DEFENSE NUCLEAR FACILITIES SAFETY BOARD

**SAFETY REVIEW
OF THE
HANFORD SPENT NUCLEAR FUEL PROJECT
DURING THE
DESIGN AND CONSTRUCTION PHASE**

**Defense Nuclear Facilities Safety Board
Technical Report**

February 2001

**Figure 3-
Storage
Newmark
Response**

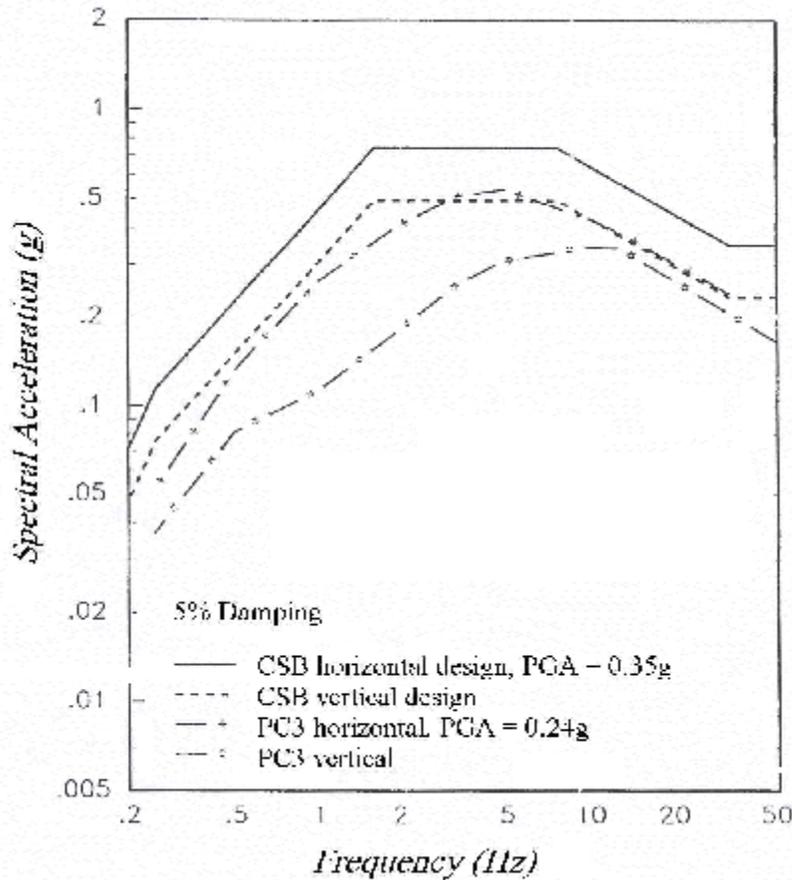
- ! The seismic excitation of the significantly embedded substructure was initially analyzed using a new, unverified computer code that is not able to account for soil-structure interaction effects directly. A more appropriate code was subsequently used for analysis of soil-structure interaction. The Board's staff performed its own analysis of how the seismic input motion is transmitted to the relatively rigid below-ground structure. As a result of discussions between the staff and SNFP personnel, the contractor made adjustments to the final in-structure response spectra. The in-structure response spectra are used for the design and qualification of equipment and components.

The issue of nuclear safety equivalency with NRC requirements was not fully achieved. When NRC requirements were not considered to be cost-effective, alternative design criteria were selected, consistent with the DOE policy. For example, even though seismic loads are the only significant loads considered in the CSB design, an exception was taken to the requirements of Appendix A to Part 100, *Seismic and Geologic Siting Criteria for Nuclear Power Plants*, 10 CFR (National Archives and Records Administration, 1999). Similarly, an exception was taken to the NRC requirements for protection against tornado missiles, based on probabilistic arguments. Although the NRC nuclear safety equivalency achieved was incomplete, the extent to which it was achieved was identified and justified by the project. Despite the anomalies, the Board considers that DOE Orders and standards provide an adequate basis for design of this facility.

The safety-class SSCs are designed using the seismic design spectrum specified in NUREG/CR-0098, *Development of Criteria for Seismic Review of Selected Nuclear Power Plants* (U.S. Nuclear Regulatory Commission, 1978), with the peak ground acceleration fixed at 0.35 times the acceleration due to the force of gravity. The design is considered sufficiently conservative since, in general, this spectrum is about 1.5 times more intense than the latest PC-3 site spectrum, and a PC-3 seismic design spectrum is generally acceptable for a Hazard Category 2 facility such as the CSB. The selected seismic design spectrum was the design requirement for the canceled HWVP. Since part of the below-ground structure was already constructed, it was deemed prudent to complete the design using the original HWVP design spectrum. A comparison of these spectra is shown in Figure 3-2.
